**Response to**  
**Request for Additional Information No. 174, Supplement 5**

**U. S. EPR Standard Design Certification**  
**AREVA NP Inc.**  
**Docket No. 52-020**  
**SRP Section: 09.02.02 - Reactor Auxiliary Cooling Water Systems**  
**Application Section: 9.2.2**

**Question 09.02.02-53:**

Figure 2.7.2-1—Safety Chilled Water System Functional Arrangement  
Sheet 1 of 4

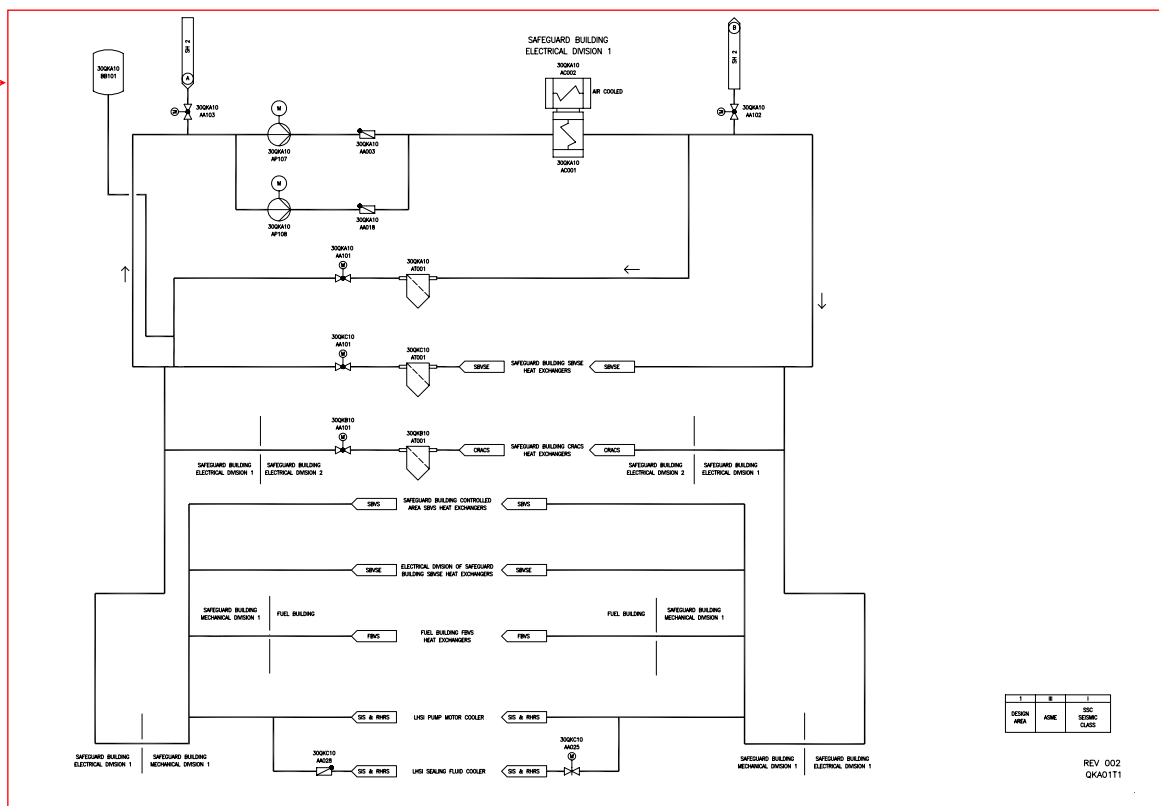
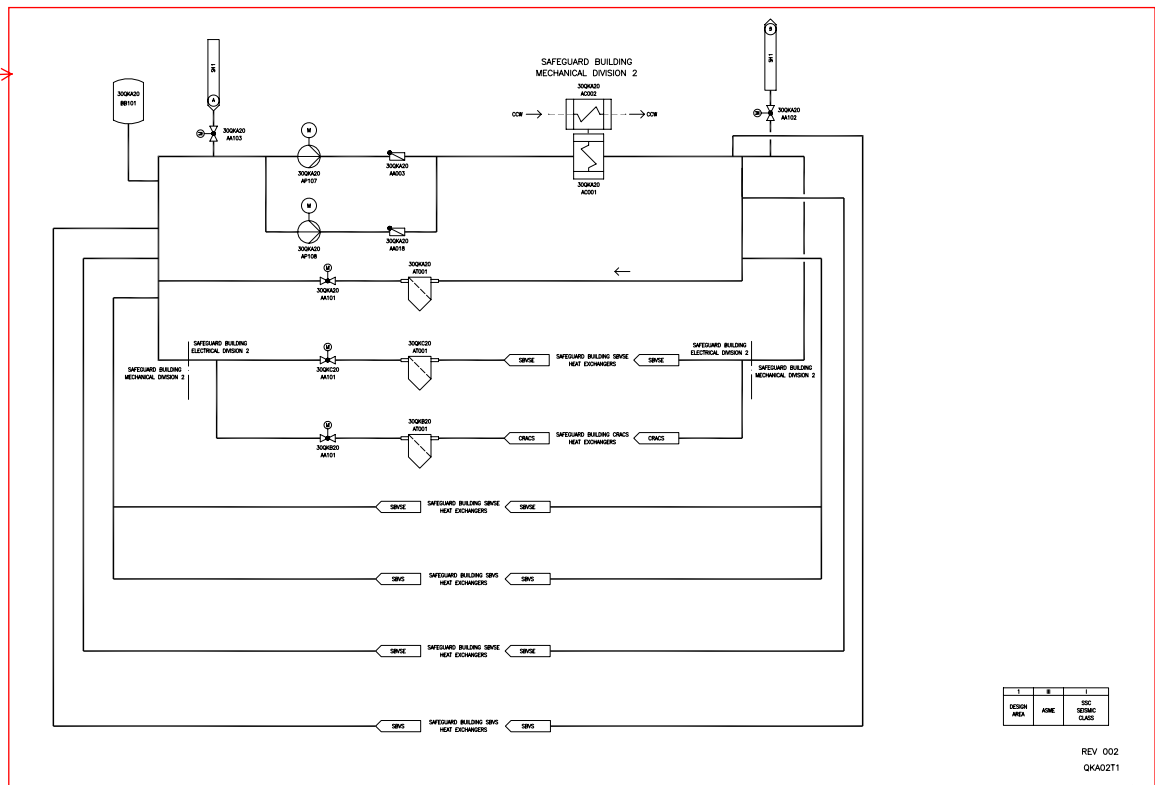
- a. The SCWS has been modified to improve the reliability of the SCWS and enhance the serviceability of the SCWS chiller packages. Cross-ties have been added to the SCWS, which interconnect the supply and return piping of Train 1 with Train 2, and the supply and return piping of Train 3 with Train 4.

Each cross-tie includes motor-operated isolation valves and associated controls and interlocks. There are two motor-operated isolation valves per division (i.e., one supply and one return), which are located in their respective Safeguard Building. The valves are divisionally-powered. During normal plant operation, the cross-tie isolation valves (i.e., supply and return piping for both trains) are normally open, with one operating SCWS chiller sized to meet the system load requirements of both divisional trains. Following a design basis accident, the system will accommodate operation as independent divisional trains with the cross-tie valves closed for an extended period.

- U.S. EPR FSAR Tier 1, Section 2.7.2.
- U.S. EPR FSAR Tier 1, Table 2.7.2-1—Safety Chilled Water System Equipment Mechanical Design, Table 2.7.2-2—Safety Chilled Water System Equipment I&C and Electrical Design, and Table 2.7.2-3—Safety Chilled Water System ITAAC.
- U.S. EPR FSAR Tier 1, Figure 2.7.2-1—Safety Chilled Water System Functional Arrangement, Sheets 1 through 4.
- U.S. EPR FSAR Tier 2, Table 3.10-1—List of Seismically and Dynamically Qualified Mechanical and Electrical Equipment, Sheet 77 of 162; and Table 3.11-1—List of Environmentally Qualified Electrical/I&C Equipment, Sheet 39 of 101.
- U.S. EPR FSAR Tier 2, Section 9.2.8.
- U.S. EPR FSAR Tier 2, Figure 9.2.8-1—Safety Chilled Water System Diagram, Sheets 1 of 4 and 2 of 4.

U.S. EPR FSAR Tier 1, Section 2.7.2, Table 2.7.2-1, Table 2.7.2-2, Table 2.7.2-3, and Figure 2.7.2-1 will be revised as described in the response and indicated on the enclosed markup.
